Access Compliance Report

Public Rights-of-Way

(Curb Ramps)

Intersection ID: 2908	Main Street: CORNER_CT	Cross Street: MEADOWVIEW_HILLS_DR	Location: NW
ADA ID: 03A453F9D810	Ramp Type: PerpDiag	Initial Pass/Fail: Fail	Overall Compliance: No
Severity Score: 35			
Codes/Mitigation Info/Possible Solution		Field Measurements/Component Compliance

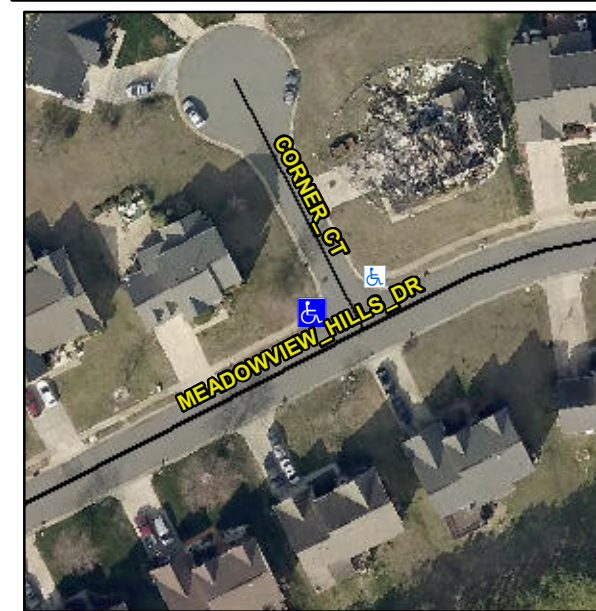
Not Found, R304.5.1, R304.2.2, R304.5.3

Compliance	Description	Data	Compliance	Description	Data
N/A	Ramp Length (in)	40.0	No	Ramp Slope (%)	15.7
No	Ramp Width (in)	38.0	No	Ramp XSlope (%)	2.8
N/A	Flare Type LT	N/A	N/A	Flare Type RT	N/A
N/A	Flare Slope LT (%)	N/A	N/A	Flare Slope RT (%)	N/A
N/A	Flare Traversable LT?	N/A	N/A	Flare Traversable RT?	N/A
N/A	Landing Length (in)	N/A	N/A	DWS Provided?	N/A
N/A	Landing Width (in)	N/A	N/A	DWS Contrast?	N/A
N/A	Landing Slope (%)	N/A	N/A	DWS Length (in)	N/A
N/A	Landing X Slope (%)	N/A	N/A	DWS Full Width?	N/A
N/A	Landing Curb? (Y/N)	N/A	N/A	DWS Offset (in)	N/A
N/A	Shared Landing?	N/A			
N/A	Gutter Ponding?	N/A	N/A	Gutter Slope (%)	N/A
N/A	Gutter Lip Ht (in)	N/A	N/A	Gutter X Slope (%)	N/A
N/A	Painted X Walk1?	No	N/A	Painted X Walk2?	No
	X Walk 1 Direction	To S		X Walk 2 Direction	To E
N/A	X Walk 1 Width (in)	N/A	N/A	X Walk 2 Width (in)	N/A
	X Walk 1 Slope (%)	3.0		X Walk 2 Slope (%)	4.1
	X Walk 1 X Slope (%)	0.1		X Walk 2 X Slope (%)	0.7

Remove & Replace Curb Ramp With Two New Directional Ramps or Equivalent.
